June 14, 2024

**RE: Federal Motor Vehicle Safety Standards; FMVSS No. 305a Electric-Powered Vehicles: Electric Powertrain Integrity Global Technical Regulation No. 20, Incorporation by Reference.**

## Additional Clarification Questions and Proposed Regulatory Text Changes

Figure 1. Voltage Measurements of the High Voltage Source- Measurement for Vb Voltage Between the Positive Side of the High Voltage Source and the Negative Side of the High Voltage Source through a Safety Breakout Box with Inline Resistors.

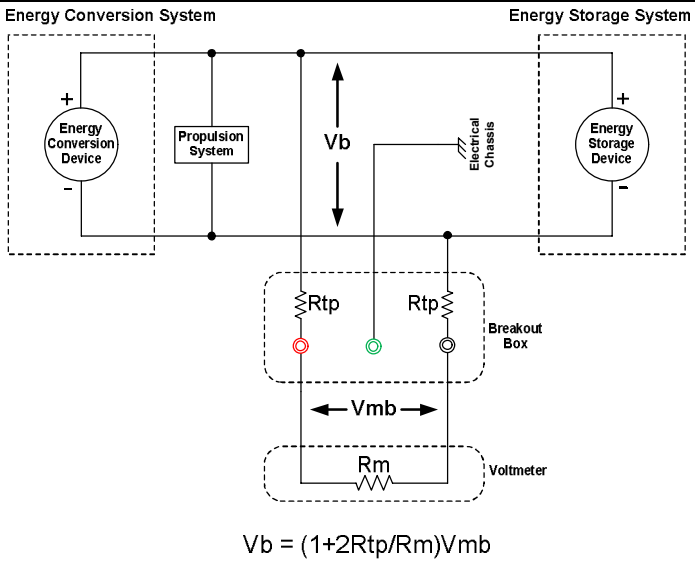
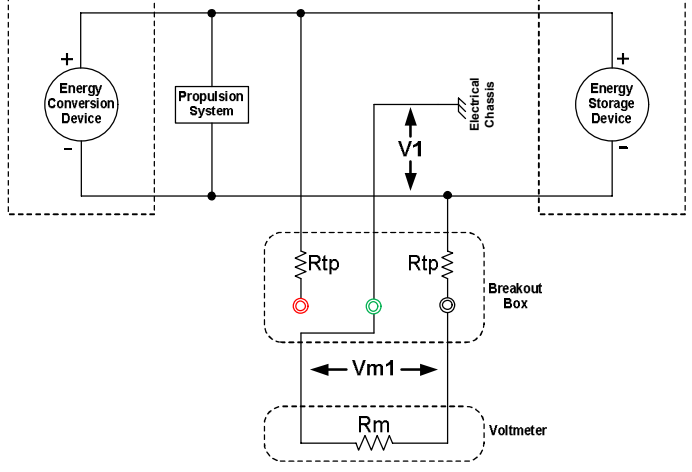
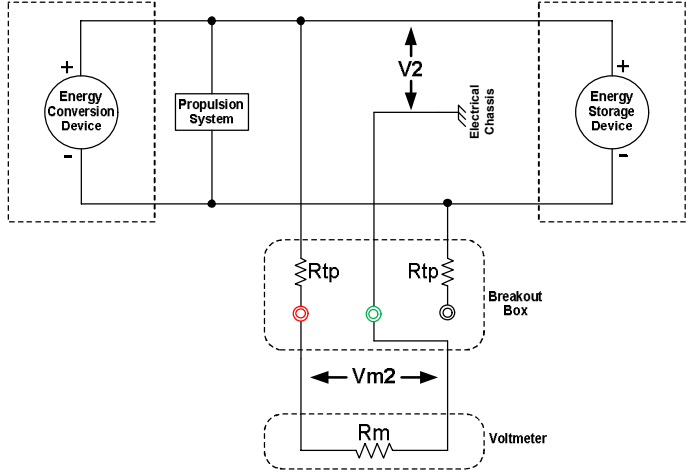
| Section number   | Comments and suggested redline edits on the proposed regulatory text  |
|------------------|---|
| S7.1.2           | <p>We propose NHTSA revise S7.1.2 as follows:<br/> <u>Voltage Vb is the voltage across the two terminals of the voltage source as shown in Figure 1. Voltage Vb is measured through a safety breakout box with inline resistors that reduce the maximum possible current exposure to a level safe for human contact. One inline resistor of the resistance value Rtp is between the testing access point and the positive side of the high voltage source. Another inline resistor of the resistance value Rtp is between the testing access point and the negative side of the high voltage source. The internal resistance of the voltmeter is Rm. The reading of the voltmeter connected to the two testing access points is Vmb. Voltage Vb is determined by the formula in Figure 1. Voltage Vb is measured across the two terminals of the voltage source.</u><br/>           Before a vehicle crash test, Vb is equal to or greater than the working voltage as specified by the vehicle manufacturer. <u>This calculation formula should be used when installing Rtp in the safety breakout box.</u></p> <p>Note: If the access point used does not include inline resistors to reduce potential current exposure levels, 0 should be substituted for Rtp in all formulas.</p> <p>The text and corresponding diagram in Figure 1 should also be revised as follows:</p> |

S7.1.3 We propose NHTSA revise S7.1.3 as follows:  
~~Voltage V1 is measured between the negative side of the high voltage source and the electrical chassis as shown in Figure 2. Voltage V2 is measured between the positive side of the high voltage source and the electrical chassis as shown in Figure 3. Voltage V1 is the voltage between the negative side of the high voltage source and the electrical chassis as shown in Figure 2. Voltage V1 is measured through a safety breakout box with inline resistors. The reading of the voltmeter connected to the two testing access points is Vm1. Voltage V1 is determined by the formula in Figure 2. Voltage V2 is the voltage between the positive side of the high voltage source and the electrical chassis as shown in Figure 3. Voltage V2 is measured through a safety breakout box with inline resistors. The reading of the voltmeter connected to the two testing access points is Vm2. Voltage V2 is determined by the formula in Figure 3.~~

The text and corresponding diagram in Figure 2 should also be revised as follows:

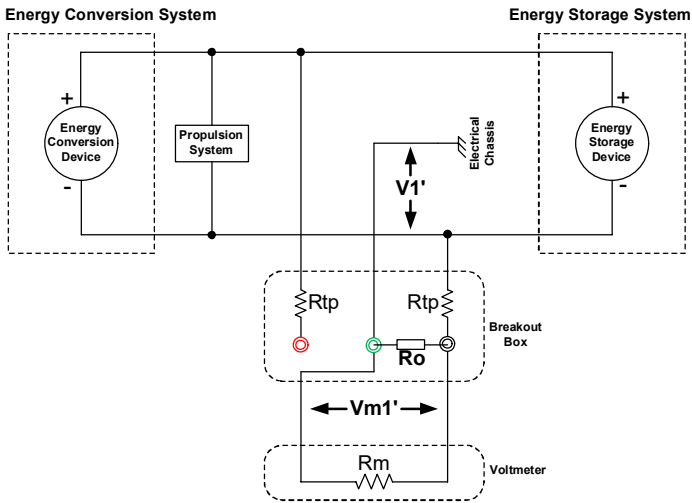
| Section number | Comments and suggested redline edits on the proposed regulatory text   |
|----------------|--|
| S7.2.1         | <p data-bbox="432 1821 948 1850">We propose NHTSA revise S7.1.3 as follows:</p> <p data-bbox="432 1854 1358 1917">If V1 is greater than or equal to V2, insert a known resistance (Ro) between the negative side of the high voltage source and the electrical chassis. With the Ro</p>  |

installed, ~~measure~~ the voltage (V1') as shown in Figure 4 ~~is~~ between the negative side of the high voltage source and the electrical chassis. The measured voltage across the resistor Ro is Vm1'. Determine V1' and calculate the electrical isolation resistance (Ri) according to the formula shown. Divide Ri (in ohms) by the working voltage of the high voltage source (in volts) to obtain the electrical isolation (in ohms/volt).

The text and corresponding diagram in Figure 4 should also be revised as follows:

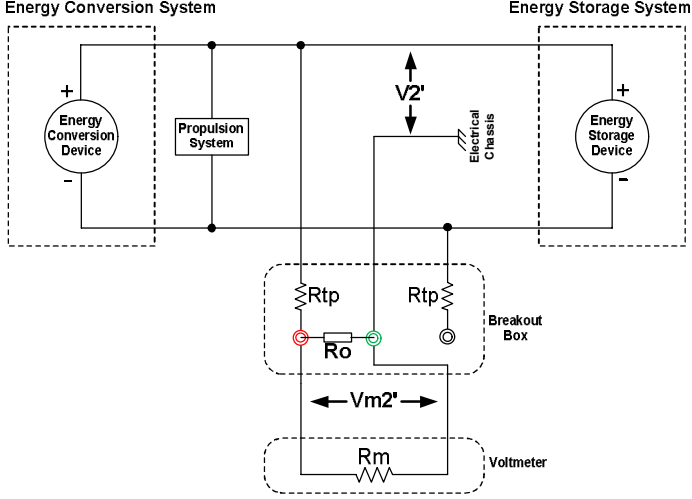
$$V1' = (1 + Rtp/Ro + Rtp/Rm) Vm1'$$

$$Ri = (Ro + Rtp) (1 + V2/V1) ((V1 - V1') / V1')$$
